METROPOLITAN GOVERNMENT OF NASHVILLE AND DAVIDSON COUNTY

STAFF RECOMMENDATION 1401 Dallas Avenue December 19, 2012

Application: Demolition-partial; New construction – addition
District: Belmont-Hillsboro Neighborhood Conservation Zoning Overlay
Council District: 18
Map and Parcel Number: 11801005800
Applicant: Blaine Bonadies, architect
Project Lead: Michelle Taylor, michelle.taylor3@nashville.gov

site / roof plan

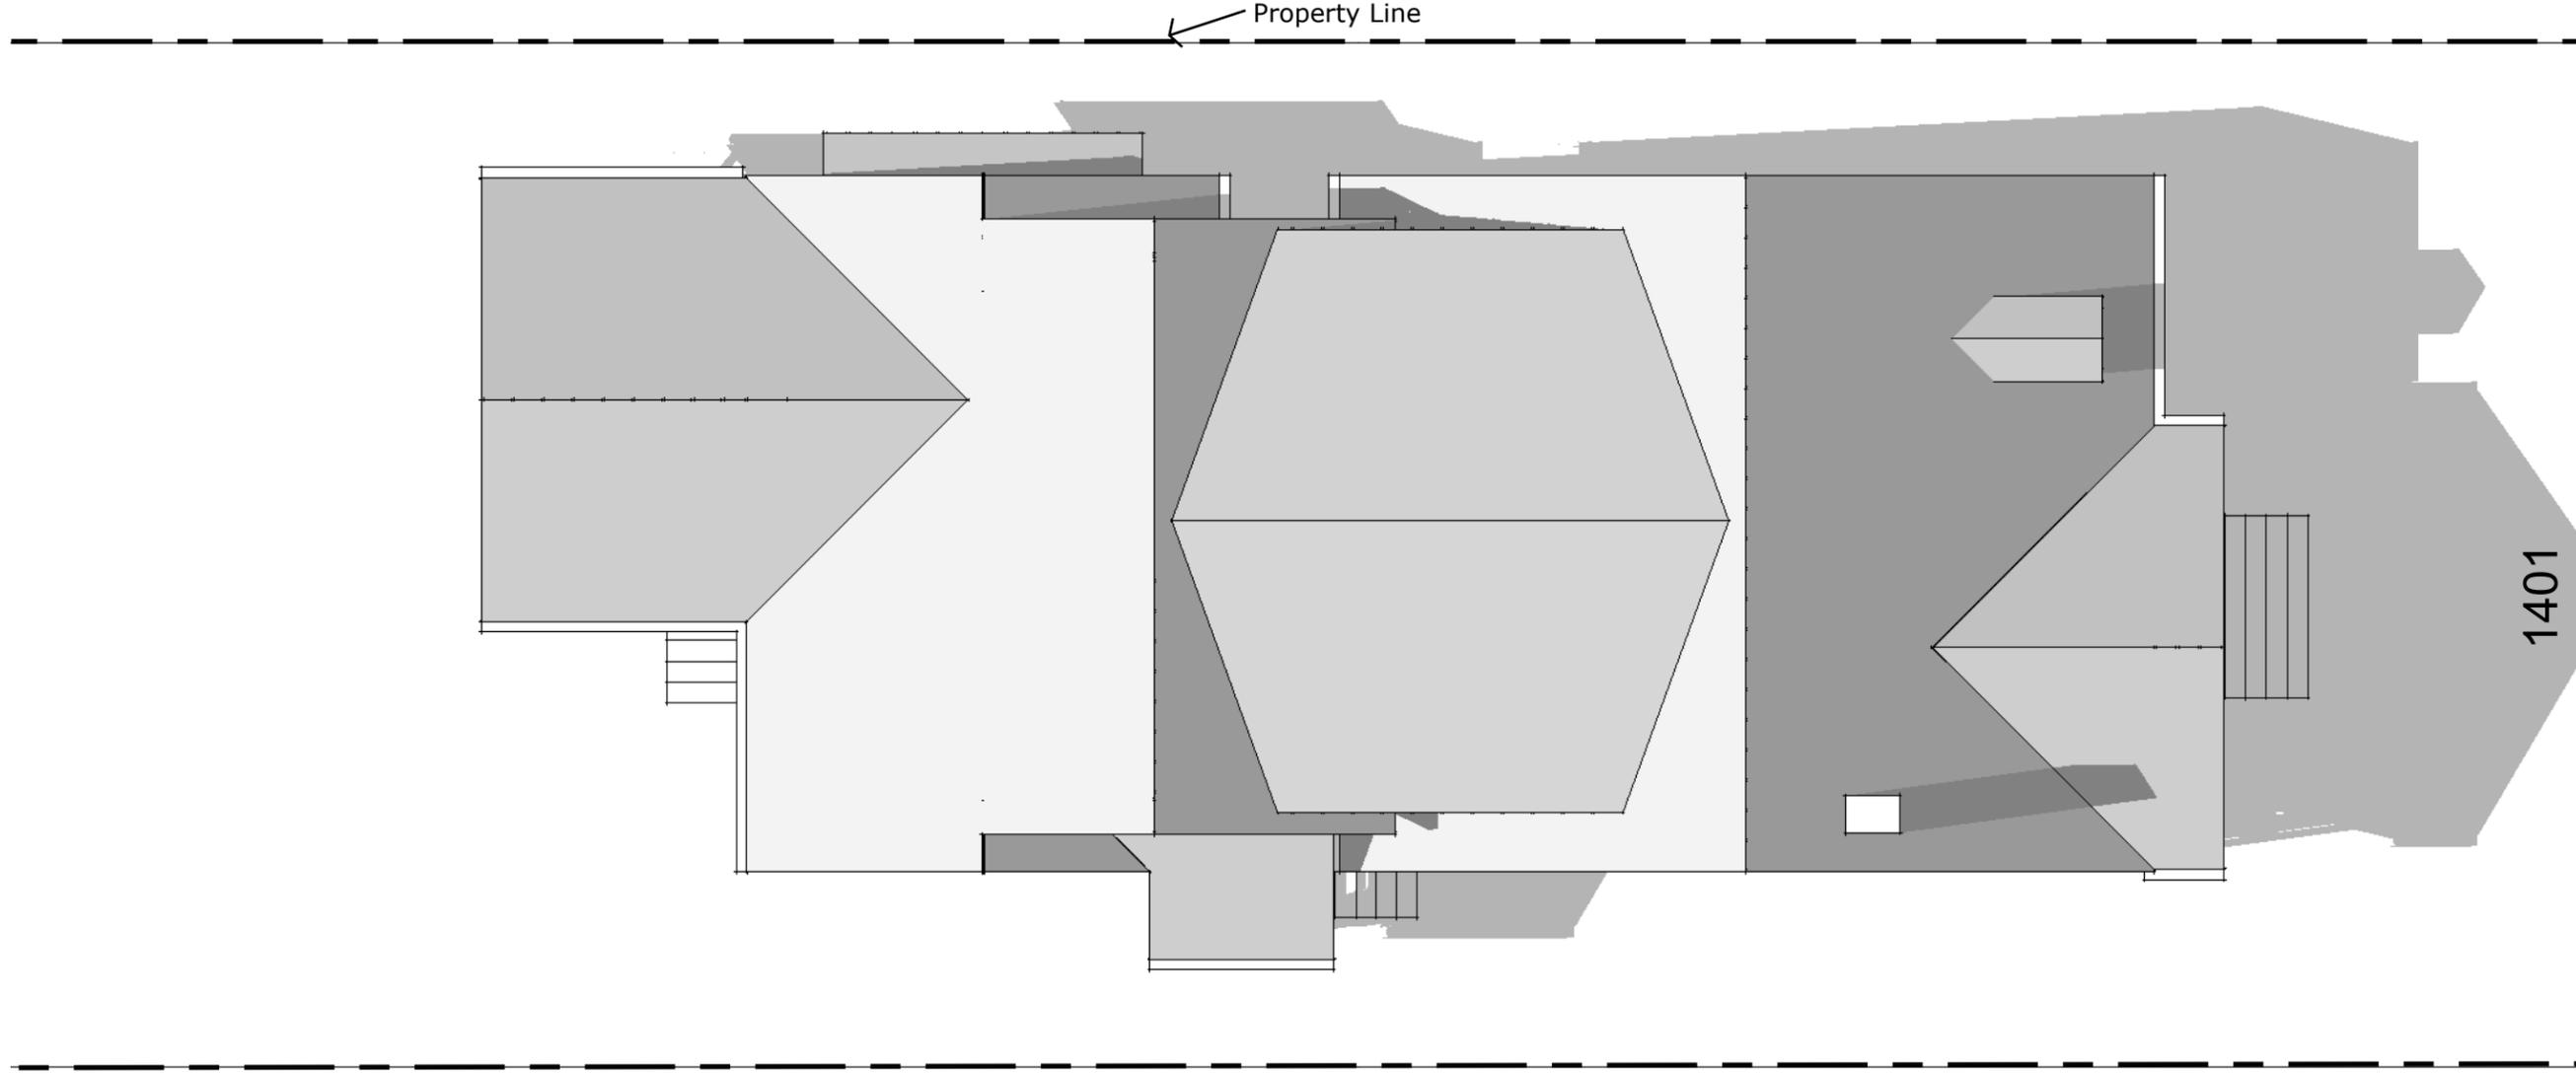
The left wall of the addition will step in two feet (2') from the historic house, carry back eight feet (8'), and then step back out to align with the left wall of the existing house. The covered porch will extend four feet (4') beyond the left wall; however, will be open in nature and only eight feet (8') deep.

The right wall of the addition will step in two feet (2') from the historic house, carry back eight feet (8'), step back out two feet (2') for a depth of three feet (3'), and then step additional two feet (2') beyond the width of the existing house. This box bay portion of the addition, which extends wider than the existing house, will extend for twelve feet before stepping back in two feet (2') to realign with the right wall of the existing house. Although, this box bay extends beyond the existing house, it is located toward the rear of the house and will be minimally visible from the right-of-way.

The proposed addition will also include a rear covered screened porch which will be twelve feet (12') deep and seventeen feet (17') wide.

Although the addition extends two feet (2') on the right side and four feet (4') on the left side beyond the existing house, staff considers the addition to be appropriate based on placement toward the rear of the addition, the open nature of the covered porch, and the fact the addition initially sets in from the existing house physically distinguishing it from the historic house.

Staff finds the location of the proposed addition does meet sections II.B.c , II.B.2.a and II.B.2.d. of the *Belmont-Hillsboro Neighborhood Conservation Zoning Overlay: Handbook and Design Guidelines*.

footprint plan

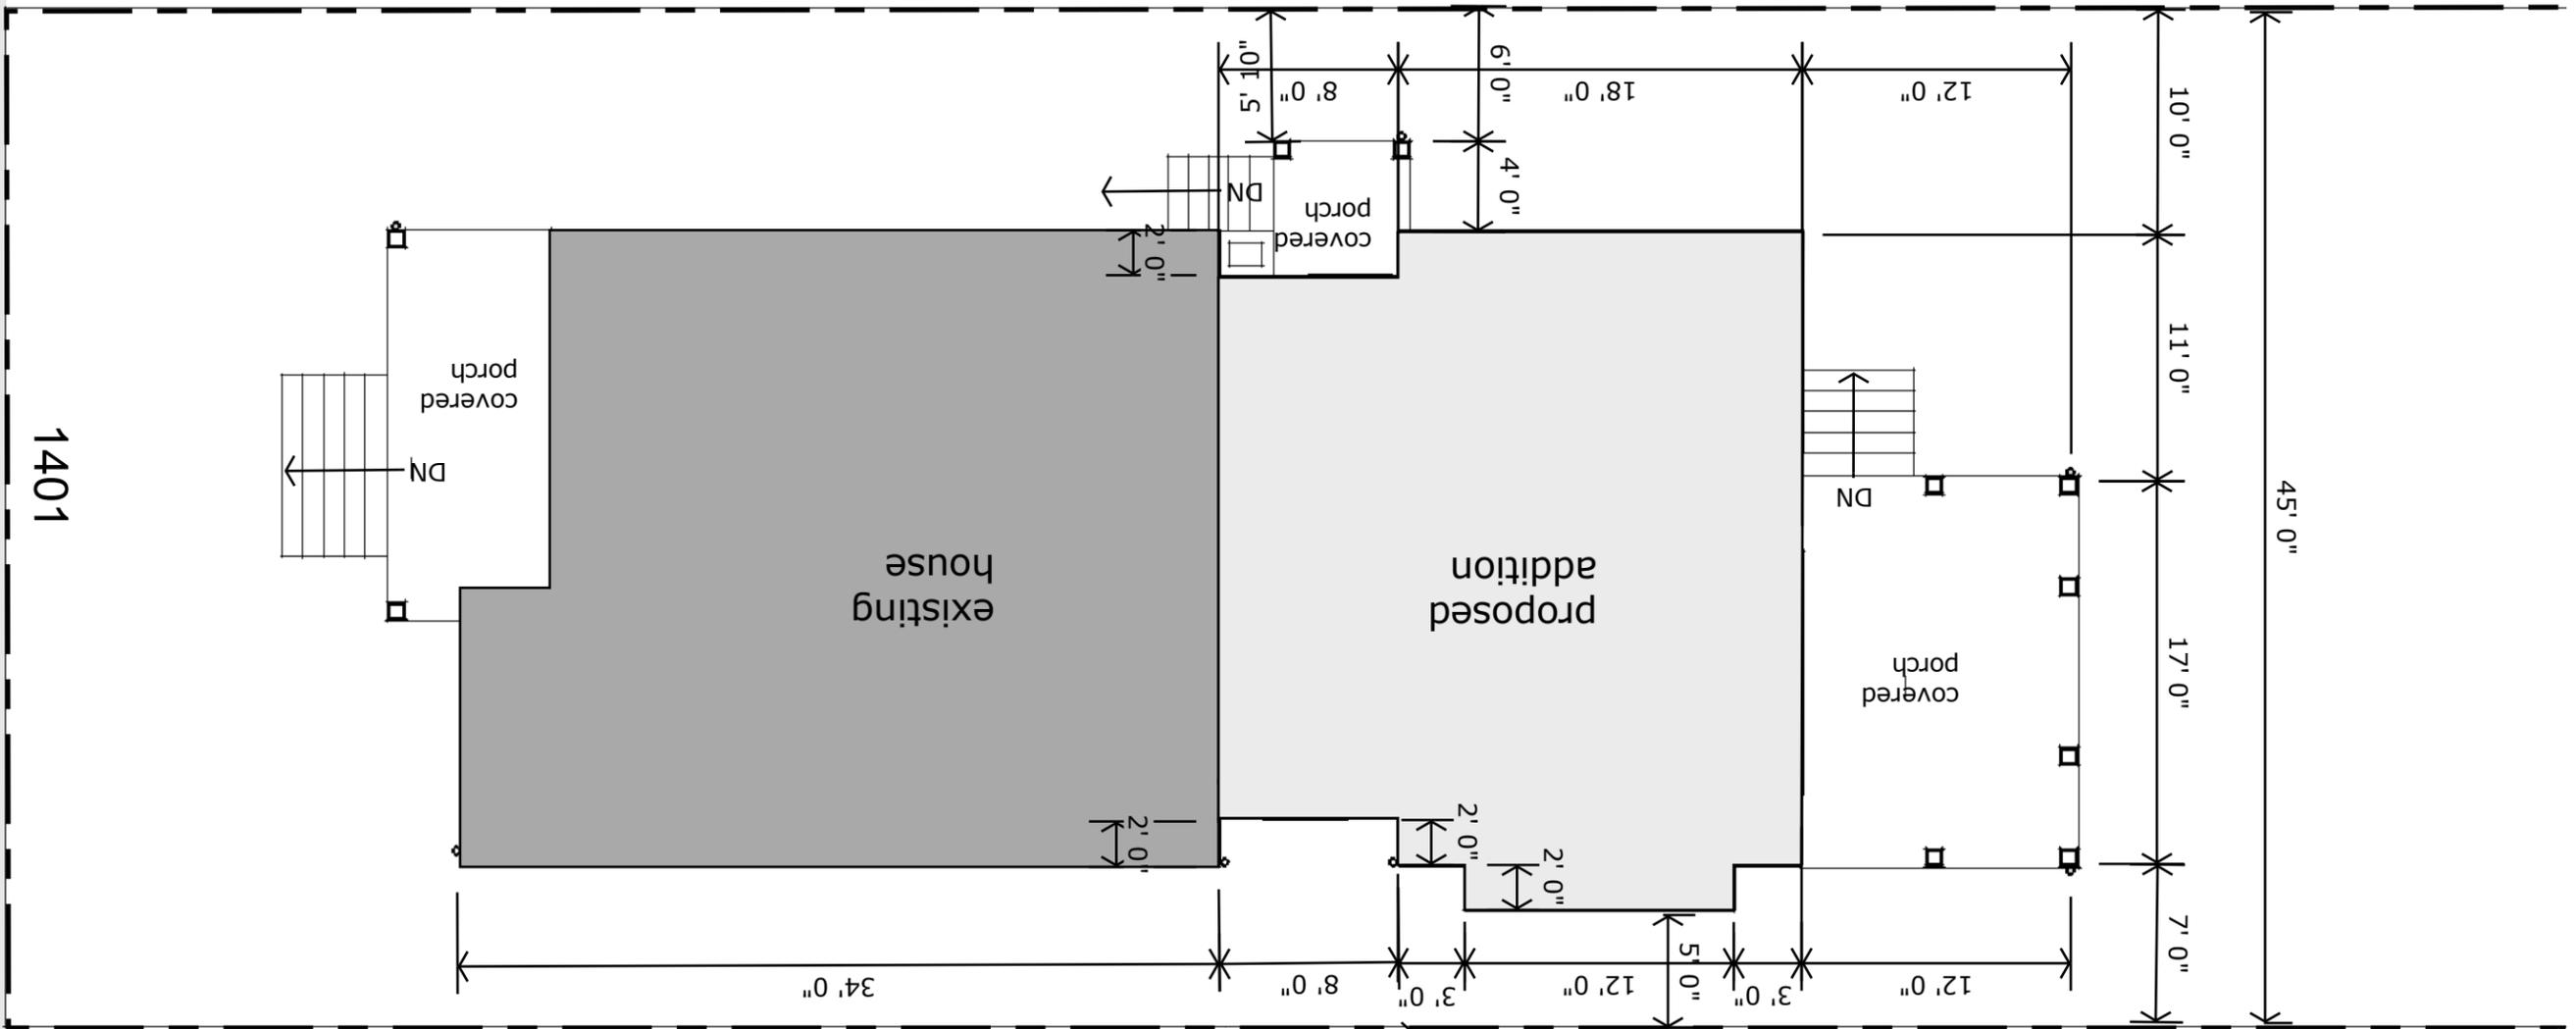
The Commission approved the application for the addition in October 2012 with the condition the addition sit in a minimum of one foot (1') on each side. The applicant has inset the main body of addition on the left side to meet this condition but still has a porch that extends beyond the left side wall and has added an additional box bay on the right

side of the addition that will extend two feet (2') beyond the wall of the existing house. Because the addition will extend wider than the existing house on both sides, the application could not be approved at the staff level.

The new addition, not including the covered screened porch will have a footprint of approximately seven hundred and four square feet (704 sq. ft.) After construction of the new addition, the percentage of open space for the lot will be approximately seventy-three percent (73%). The addition will reduce the lot's open space by approximately twelve percent (12%). Staff finds this reduction in open space to be appropriate because the resulting open space is still compatible with the open space ratios of the immediate context, which range from sixty to ninety percent (60% - 90%).
